DWN	C.C.	10-93	ROCKFORD CORPORATION FOSGATE DIVISION TEMPE AZ
CHK			
ENGR	C.C.	10-93	TITLE SERIES ONE 4600 SCHEMATIC
APVD			
APVD			SIZE B / SCALE / SHEET 1 OF 2
MATL/FS			FILE NAME: SCH0513G / PART NO.: SCH-0513-G / REV: AA

DWN	C.C.	10-93	ROCKFORD FOSGATE CORPORATION DIVISION TEMPE AZ	
CHK				
ENGR	C.C.	10-93	TITLE: SERIES ONE 4600 SCHEMATIC	
APVD				
APVD			SIZE B	SCALE / SHEET 2 OF 2
MATL/FS			FILE NAME: SCH0513F	PART NO.: SCH-0513-F / REV: AA

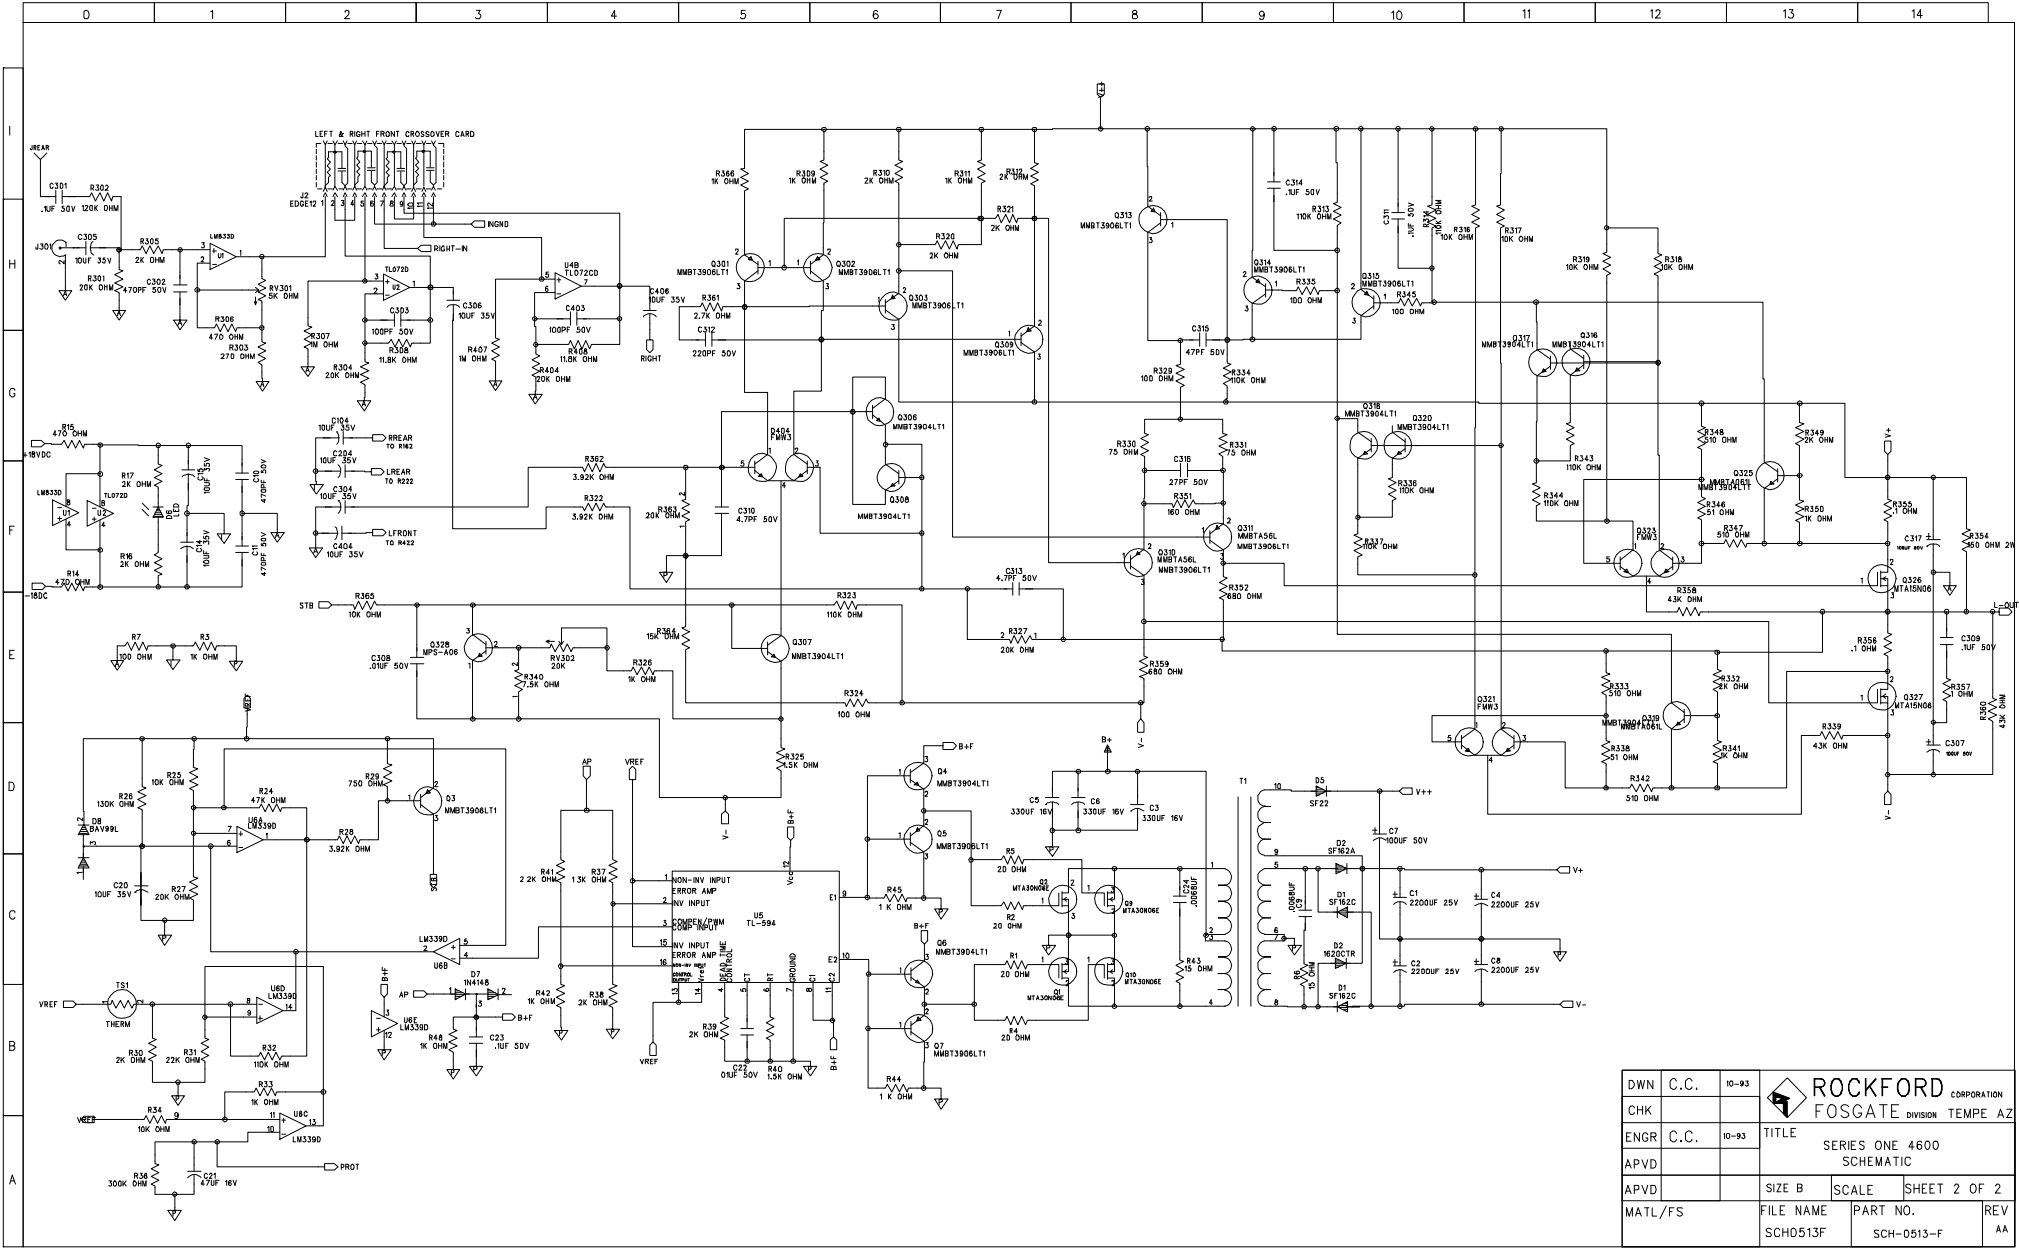
SS-210SM (BCX71J) HAS BEEN
REPLACED. REF DES Q112, 113
Q312, Q412
NEW PART # SS-204SM (MTB5401L(
PER ECO 3564

RM/10-105B (1M 5%) REF DES R35
HAS BEEN REMOVED PER ECO 3640

CERHF-337BL-024 (330uf 16v) HAS
BEEN REPLACED. REF DES C3 5 6
NEW PART # CERHF-337I-024 (330uf 16v)
PER ECO 3673

SS-204SM (MMBT5401L) HAS BEEN DELETED
REF DES Q112 212 312 412
RM/10-114B (110K) HAS BEEN DELETED
REF DES R128 228 328 428
PER ECO 3737

SS-260SM (BAV99L) HAS BEEN REPLACED
REF DES D7
NEW PART # SS-162-051 1N4148
PER ECO 3656

SS-761 (MTA30N6E) HAS BEEN
REPLACED. REF DES Q1 2 9 10
NEW PART # SS-0967 (IRFZ42)
PER ECO 3758

SS-209SM (BCX70J) HAS BEEN REPLACED
REF DES Q4 6 306 307 308 316 317 318 320
NEW PART # SS-0792 (MMBT3904LT1)

SS-210SM (BCX71J) HAS BEEN REPLACED
REF DES. Q3 5 7 301 302 303 309
312 313 314 315
NEW PART # SS-0791 (MMT3906LT1)
PER ECO 3566

SS-760-046 HAS BEEN CHANGED
REF DES Q126 127 226 227
326 327 426 427
NEW PART # SS-RFP15N06 (TO-220 HARRIS)
PER ECO 3678

PRIMARY PART # SS-802SM TL494
SUBSTITUTE PART # SS-0722 TL594
PER ECO 3450

SS-760-047 HAS BEEN REPLACED
REF DES Q126 127 226 227
326 327 426 427
NEW PART # SS-760-046
PER ECO 3619

CERHF-337I (330UF 16V) HAS BEEN
REPLACED. REF DES C3 5 6
NEW PART # CERHF-337BL (330UF 35V)
PER ECO 3667

SS-760 (MTA15N06) HAS BEEN
REPLACED. REF DES Q126 127
226 227 326 327 426 427
NEW PART # SS-RFP15N06 (TO-220 HARRIS)
PER ECO 3713

SS-0967 (IRFZ42) HAS BEEN
REPLACED. REF DES Q1 2 9 10
NEW PART # SS-761 (MTA30N06E)
PER ECO 3791

FOR REF DES Q4, 6, 8, 306, 307
308, 316, 317, 318, 320
PRIMARY PART # BCX70J
SECONDARY PART # BC846BL
PER ECO 3419

RM/10-821B (820 OHM 1/10W 5%) HAS BEEN
REPLACED. REF DES R125 R225 R325 R425
NEW PART # RM/10-152B (1.5K 1/10W 5%)
RM/10-2002B (20.0K /10W 5%) HAS BEEN
REPLACED. REF DES R140 R240 R340 R440
NEW PART # RM/10-752B (7.5K 1/10W 5%)
PER ECO 3533

PRIMARY PART IS SS-RFP15N06-047
TO-220 HARRIS
REF DES Q126, 127, 226, 227,
326, 327, 426, 427
SECONDARY PART # IS SS-760-047
MTA15N06
PER ECO 3494
